SUBJECT: SEP TOPICS II-1.8, POPULATION DISTRIBUTION AND  
III-4.D, SITE PROXIMITY MISSILES - R. E. GINNA

R. E. GINNA  
SYSTEMATIC EVALUATION PROGRAM TOPIC  
II-1.B, POPULATION DISTRIBUTION

SEP REVIEW  
OF  
PIPE BREAK OUTSIDE CONTAINMENT  
TOPIC III-5.B  
FOR THE  
R. E. GINNA NUCLEAR POWER PLANT

FIGURE 1  
0-5 MILE 1980 POPULATION ESTIMATE

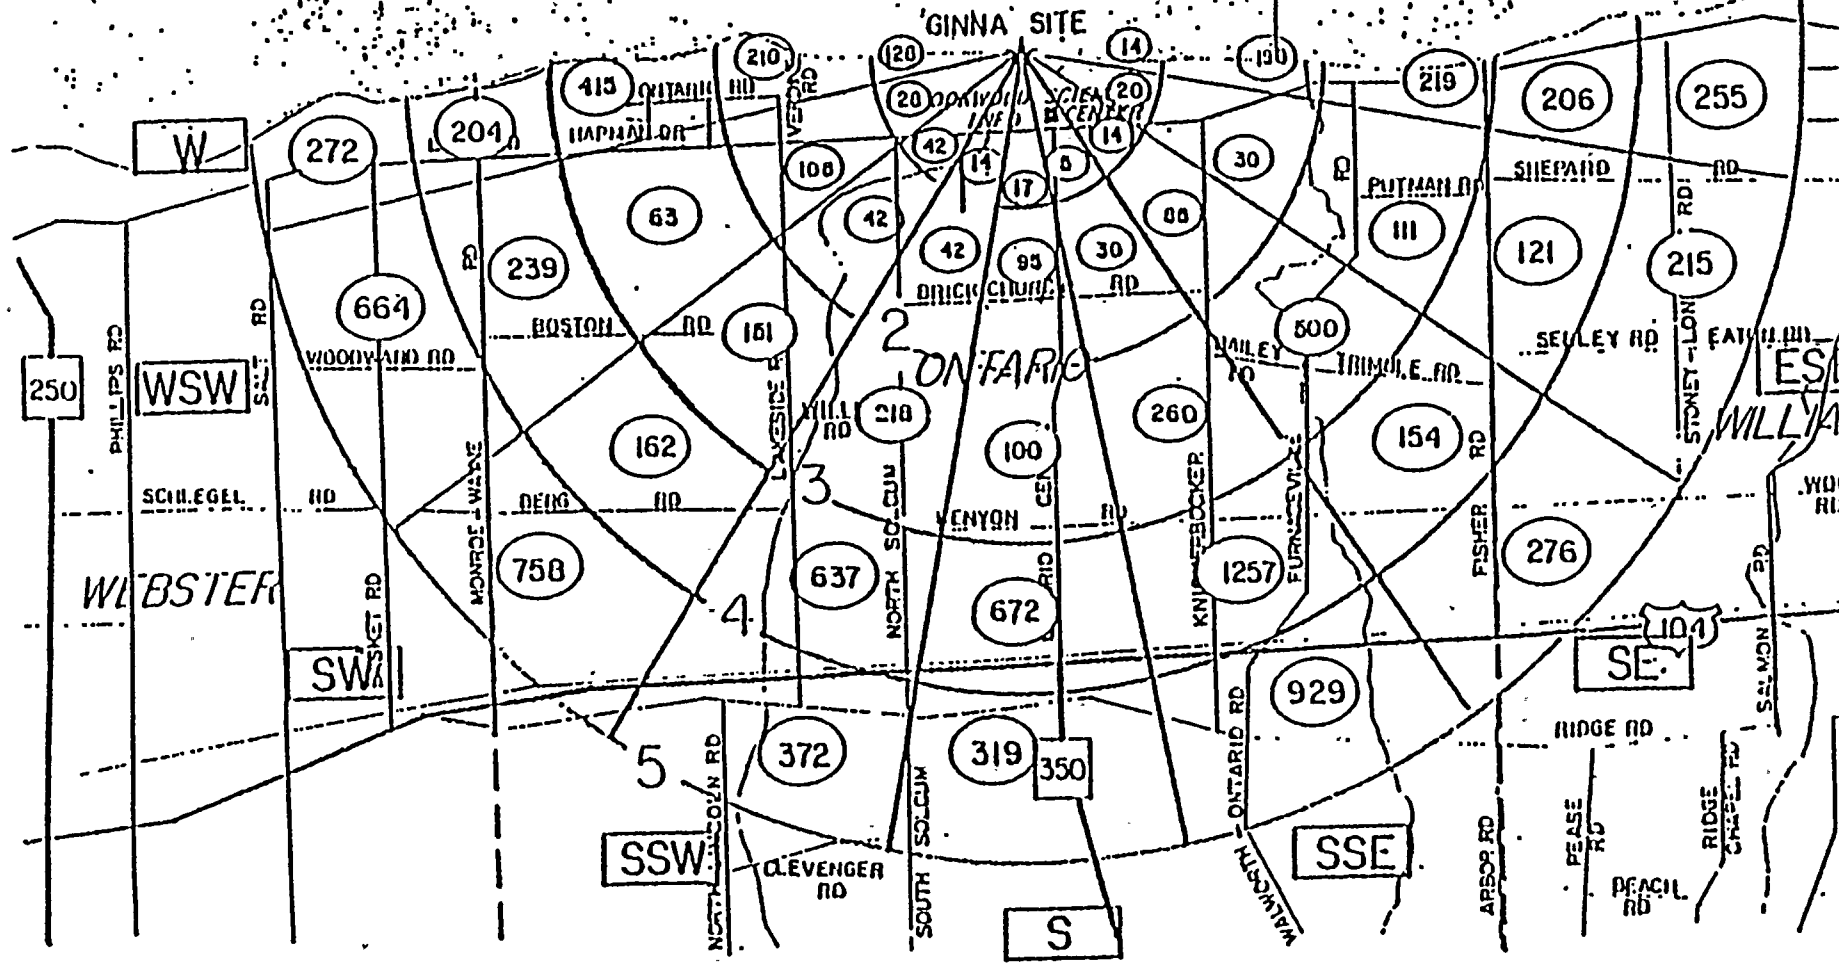
You will note that we have revised your calculated population density which is more properly obtained by dividing the total population within a given distance by the total area of the complete circle (including both level and water) whose radius is the distance of interest.

of this evaluation, details the population within 5 miles of Ginna, based on preliminary 1980 population estimate. RG&E estimates that 10,864 persons reside within five miles of the plant, a density of 138 persons per square mile averaged over the entire area. (It should be noted that this figure compares favorably with the 1980 population projection of 10,934 persons shown in Figure 2.4-2 of the Ginna FSAR, which was published in 1968).
